STAFF RECOMMENDATION
1320 Rosa L. Parks Blvd
June 16, 2021

Application: New Construction - Infill
District: Germantown Historic Preservation Zoning Overlay
Council District: 19
Base Zoning: CS
Map and Parcel Number: 081 12 0 444.00
Applicant: John Root
Project Lead: Jenny Warren, jenny.warren@nashville.gov

Description of Project: Application for the new construction of a four-story residential infill project.

Figure 3. North elevation

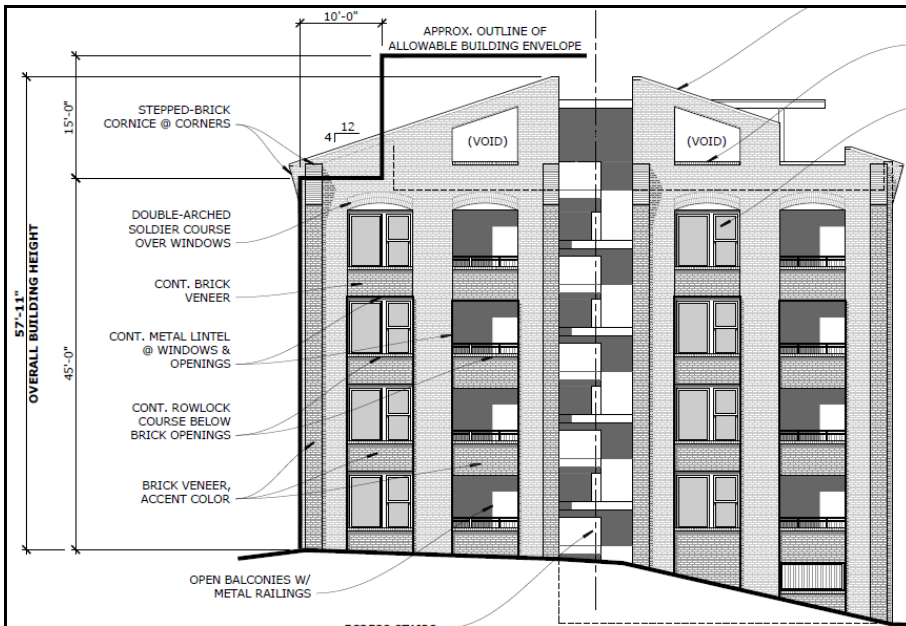
The proposed building is four stories with a maximum height of about forty-seven feet (47') on Rosa L. Parks. A partial fifth floor is proposed- this is mostly covered seating and open seating areas, but also includes fully enclosed spaces for a fitness room, bathroom and storage areas. (See Figure 5) The enclosed sections sit more than twenty feet (20') back from the building face on Rosa L. Parks. Staff finds the infill meets Section III.D.3.c of the design guidelines for height.

Figure 4. Site plan. Secondary entrances and walkways not showing here, but will be provided.

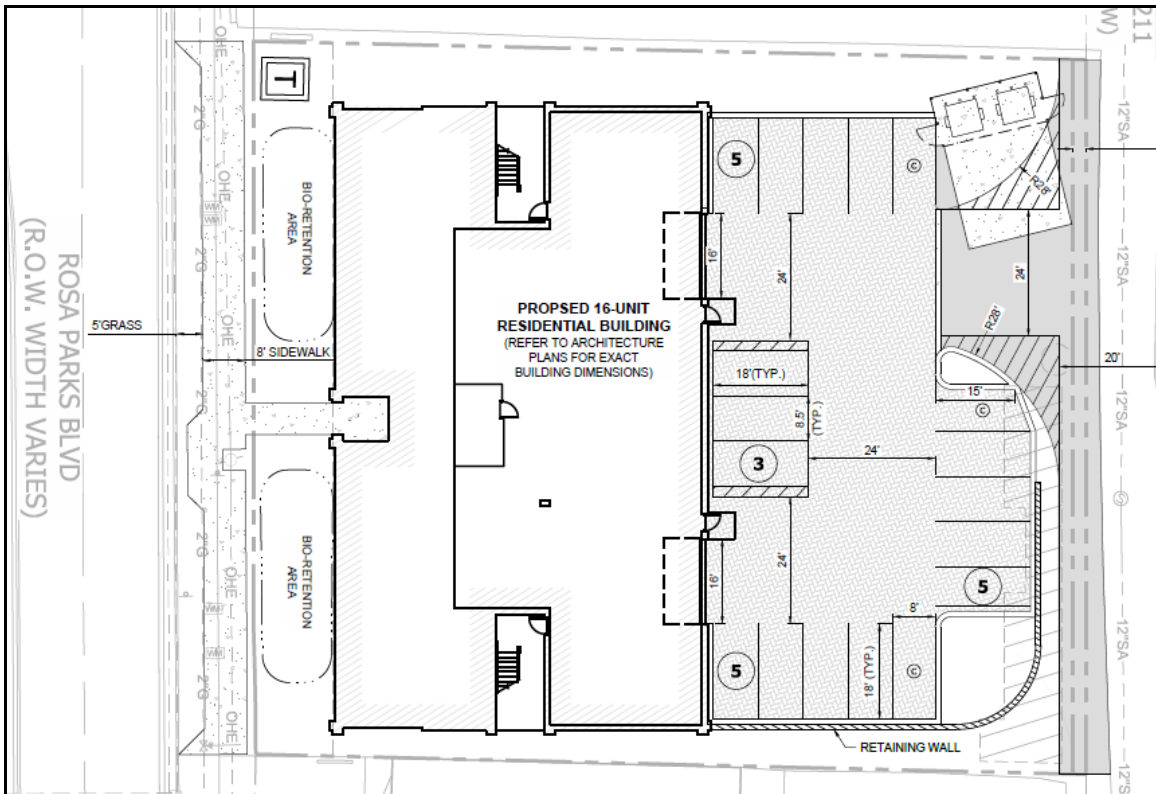
Setbacks: The guidelines state that setbacks along Rosa L. Parks Blvd should be approximately twelve feet (12') from the sidewalk, in order to be consistent with the historic Werthan campus. The front setback from Rosa L. Parks is proposed to be approximately seventeen feet (17'). Although the proposal exceeds the twelve foot (12') setback, it does so because it has a residential use where additional space between street and building is desired. Because the building is oriented to the street, does not include a storefront and does protrude into the back half of the lot, staff finds the additional front setback to be appropriate.

1. A revised site plan shall be provided, showing the secondary entrances on the primary façade, as well as the walkways;
2. MHZC staff shall review and approve the following materials prior to purchase and installation: brick, the metal siding, final doors, garage doors, windows, balcony railings, retaining wall and walkway materials and roofing color; and
3. Staff shall review and approve any exterior lighting, including rooftop lighting; retaining walls, or other appurtenances.

Figure 5. Fifth Level/Rooftop plan. Note seating areas and mechanical units screened by partially gabled roof

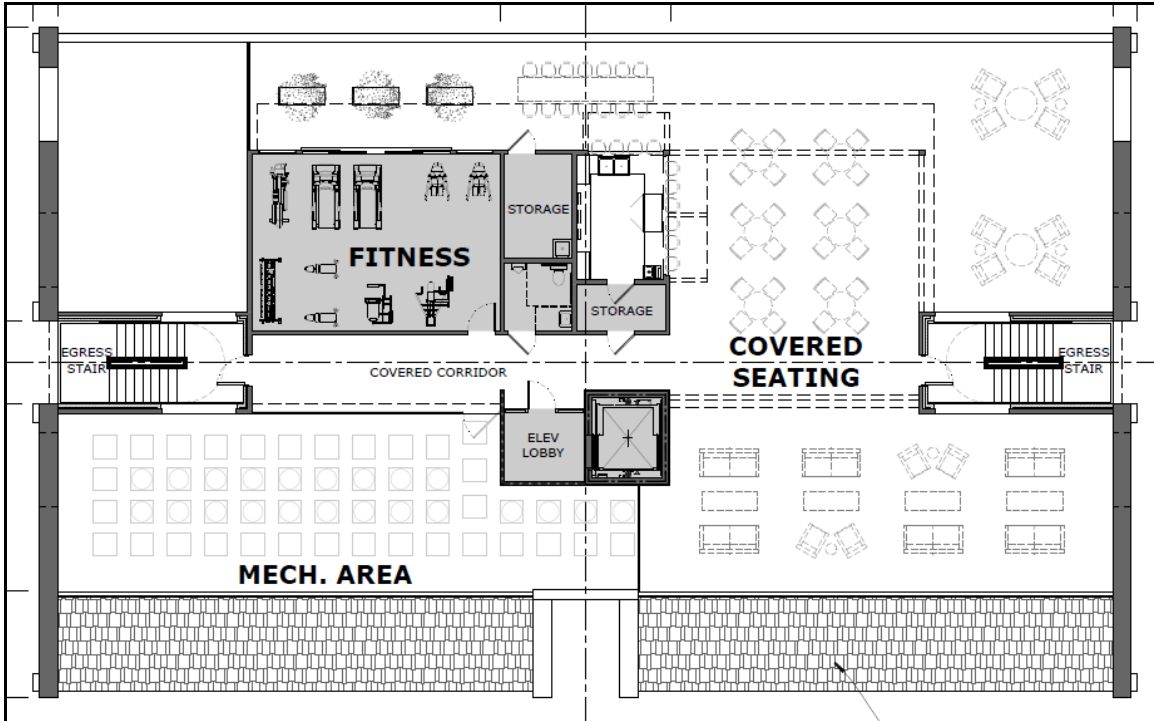
Roof Top Decks: While not quite a rooftop deck, the project does propose an active rooftop at the fifth level. (Figure 5) There will be covered seating and open seating areas. The rooftop uses will not cantilever from the building, no lighting will be permitted more than forty-two inches (42") above the floor level and the useable space will sit back from the front wall more than ten feet (10'). The rooftop use meets Section III.E.9 of the guidelines. In addition, the building itself does not extend into the rear half of the lot; therefore, the rooftop deck will not be hanging over the smaller scale of the interior of the neighborhood.

Utilities/Mechanicals: The mechanical units are shown on the roof and will be screened behind the partial gabled roof section on the front and the angled parapet on the side. The proposal meets Section III.E.10 of the design guidelines.

Figure 5. Proposed primary façade. Note prominent entrance and secondary entrances.

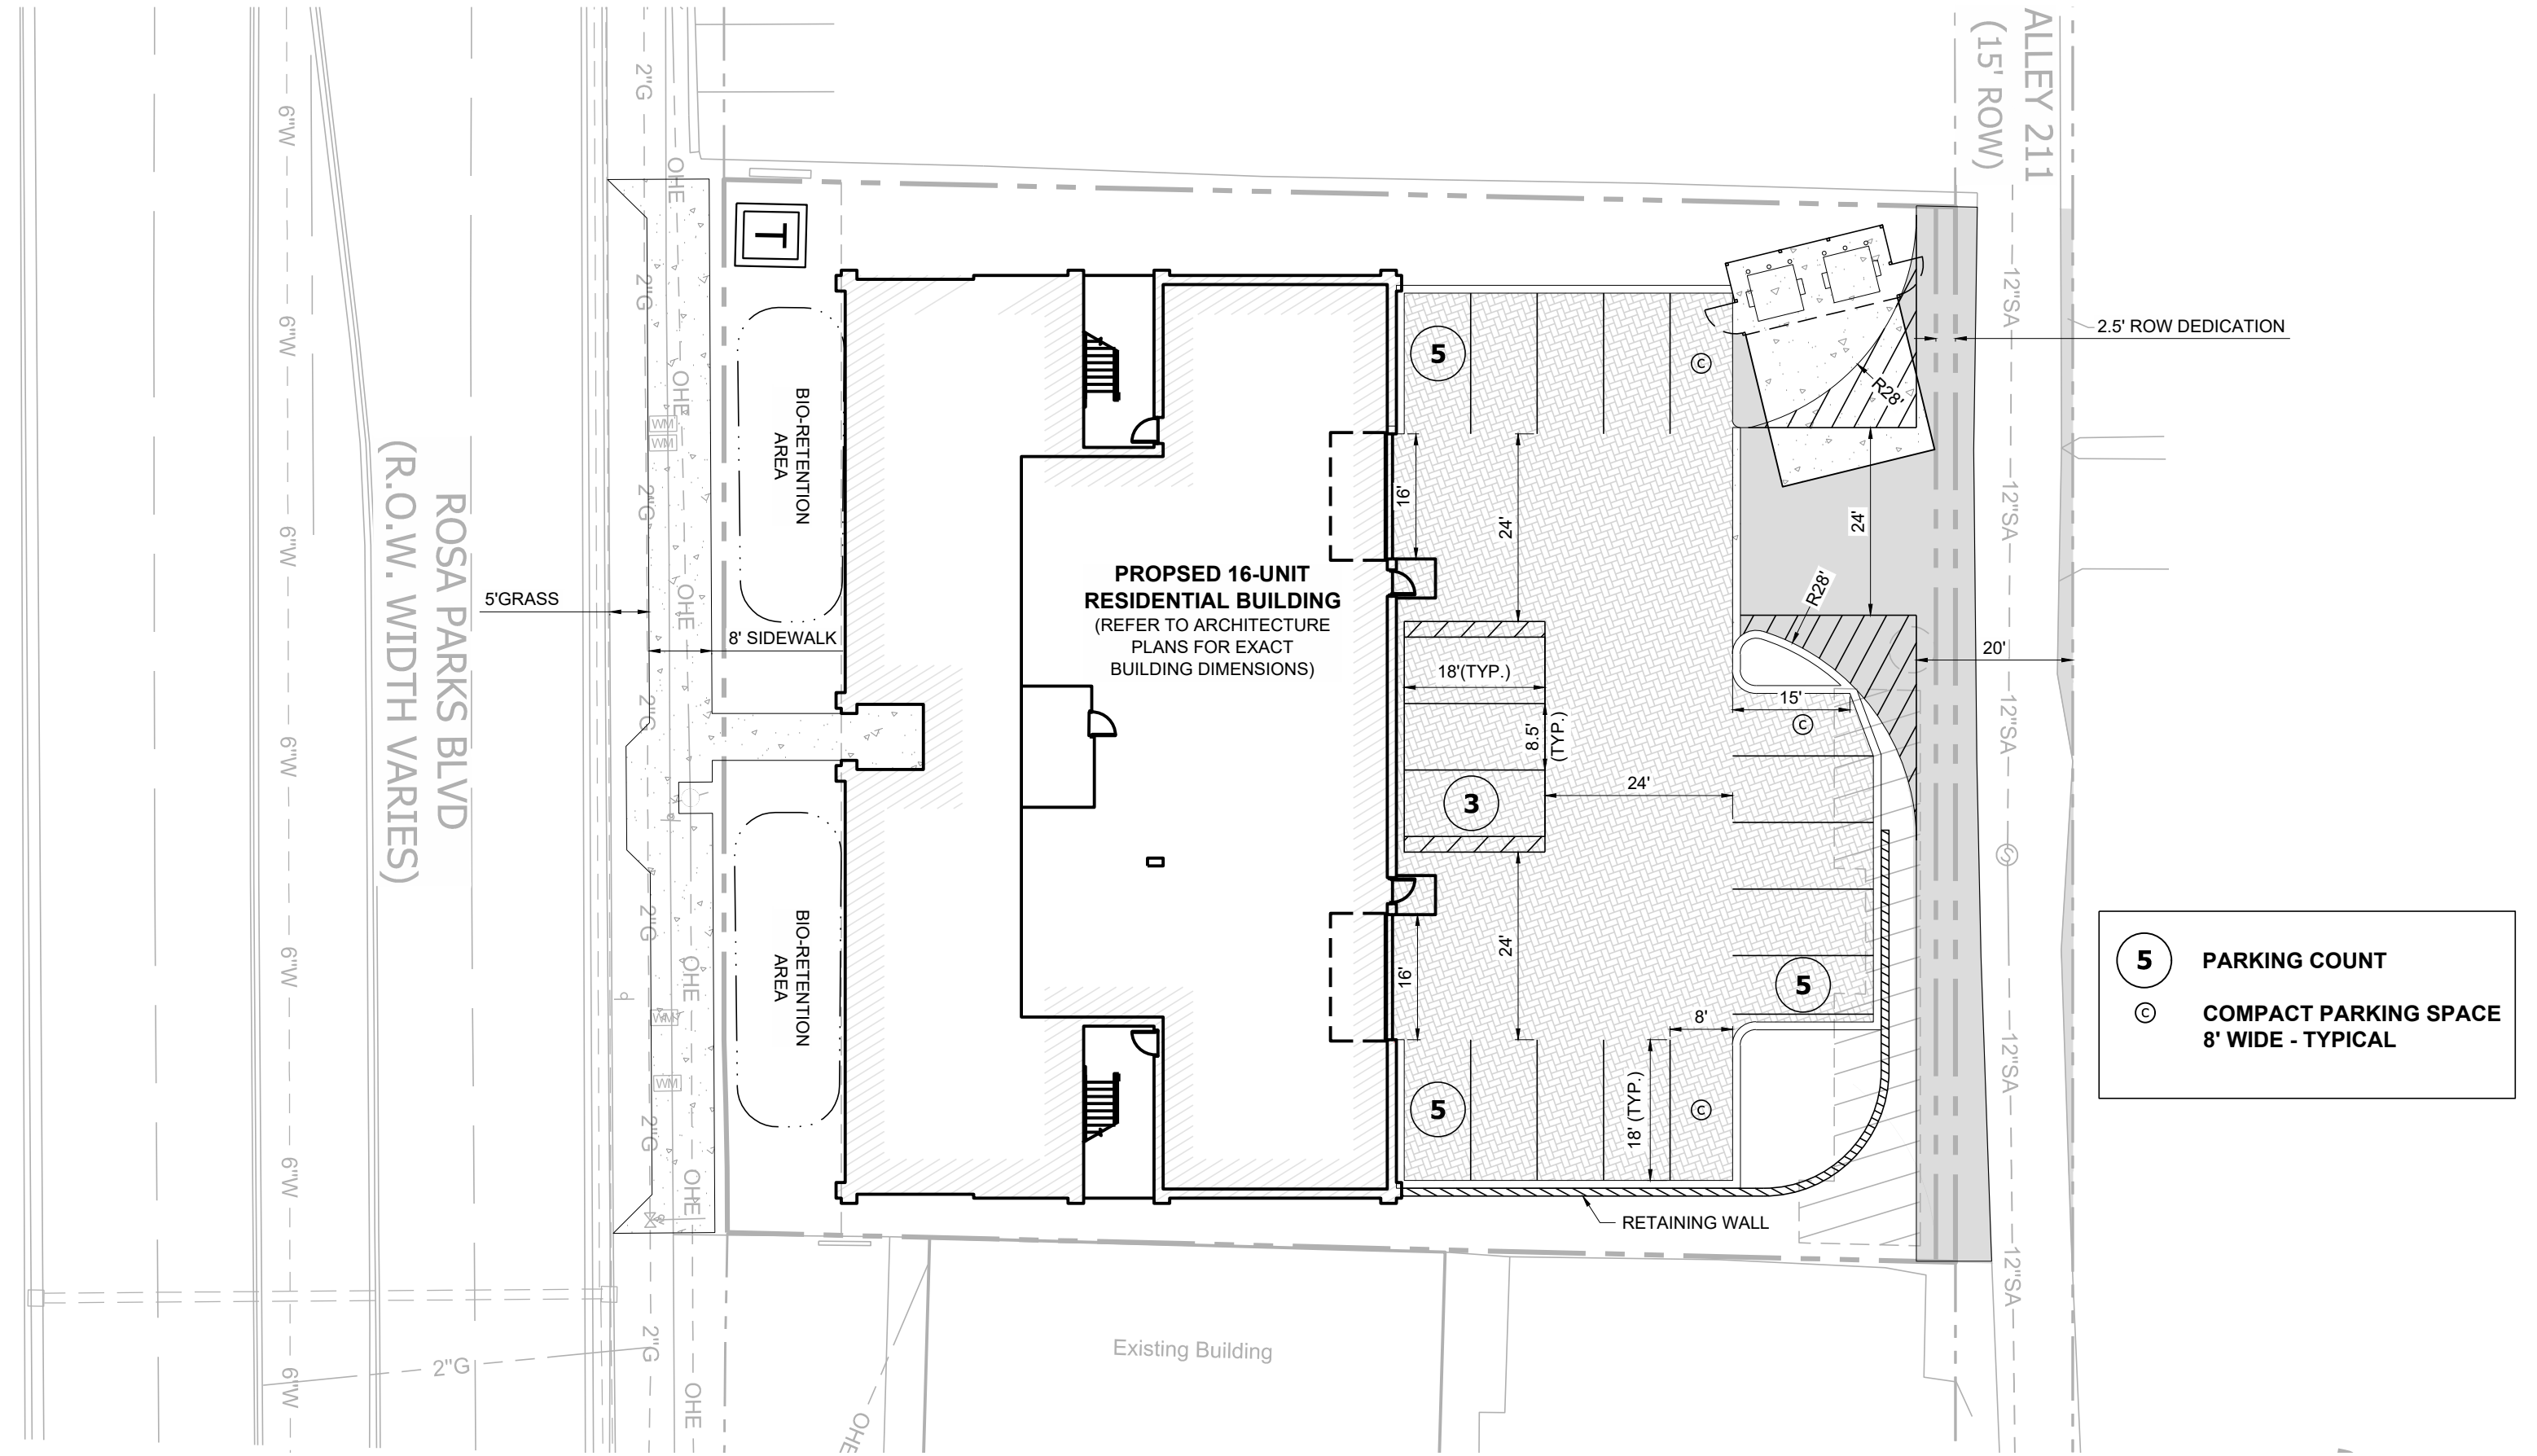
Primary Entrances: The primary entrance is located along Rosa L. Parks Blvd and emphasized by a recessed vertical bay with a change in material. Above the double doored entry is a projecting canopy. While not a porch, as a traditional single-family house would exhibit, staff finds this treatment to be appropriate as an entry to a residential structure of this scale. Two recessed secondary entrances are provided in bays two and nine.
